## HISTORIC AND DESIGN REVIEW COMMISSION

October 07, 2015

**HDRC CASE NO:** 2015-401  
**ADDRESS:** 714 N PINE ST  
**LEGAL DESCRIPTION:** NCB 1659 BLK G LOT 5  
**ZONING:** R6 H  
**CITY COUNCIL DIST.:** 2  
**DISTRICT:** Dignowity Hill Historic District  
**APPLICANT:** Leo Parker  
**OWNER:** Leo Parker  
**TYPE OF WORK:** window replacement

### REQUEST:

STAFF RECOMMENDATION FOR WINDOW REPLACEMENT

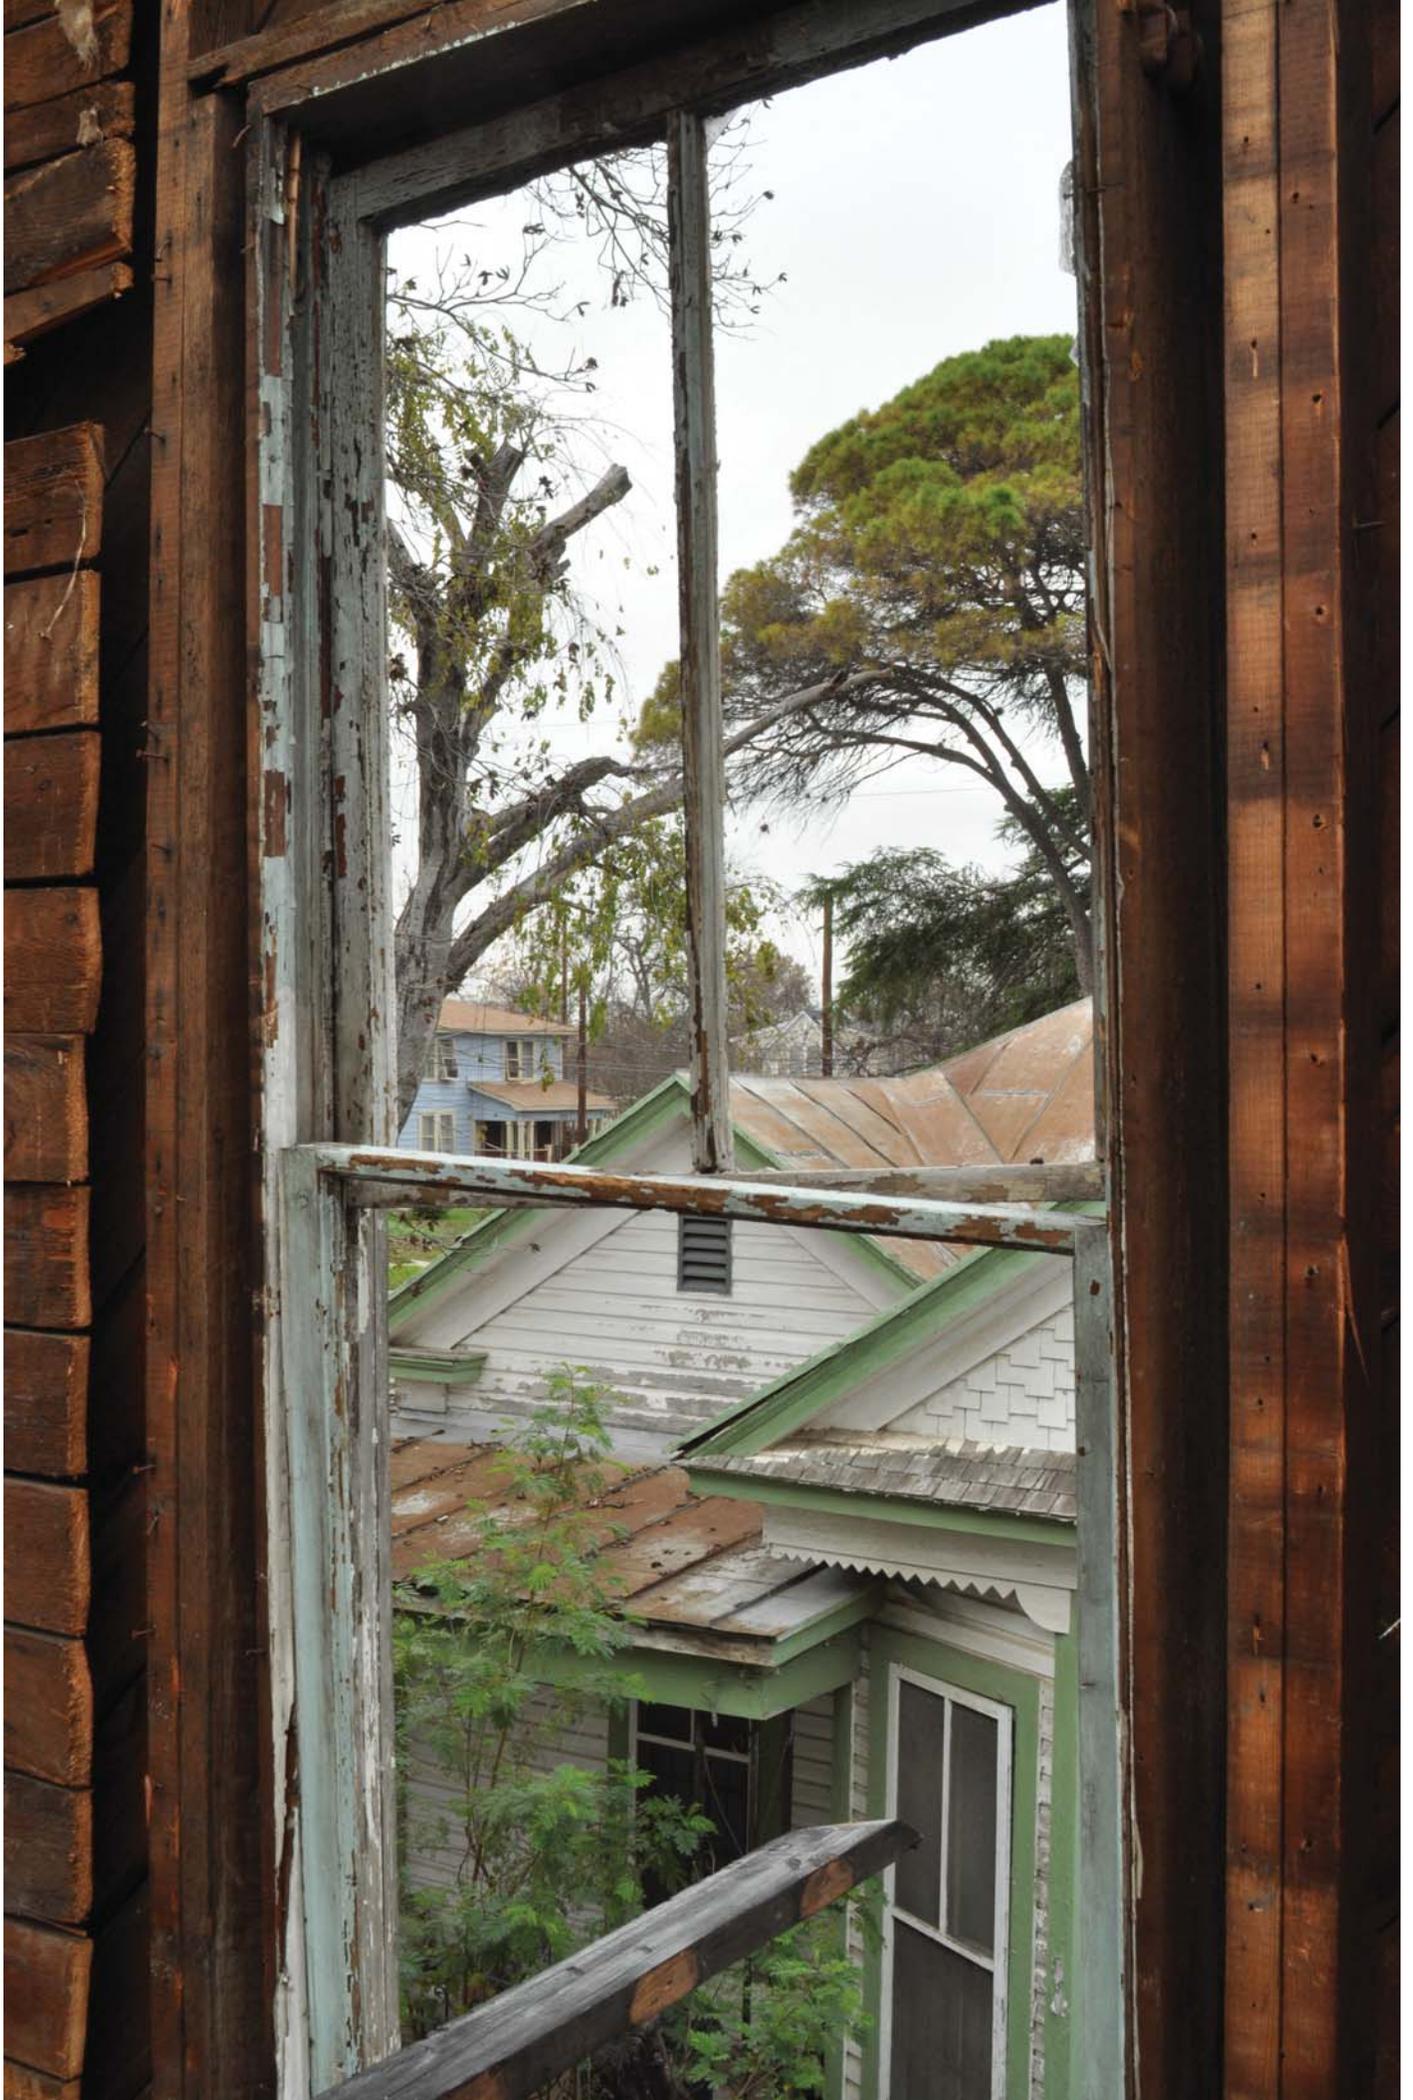
Wood windows recommended for fire-damaged windows that are beyond repair

Block-frame vinyl windows are recommended should the HDRC find a change in material to be appropriate

Vinyl windows with a flush flange or nailing strip protrude beyond the window trim and are not recommended.
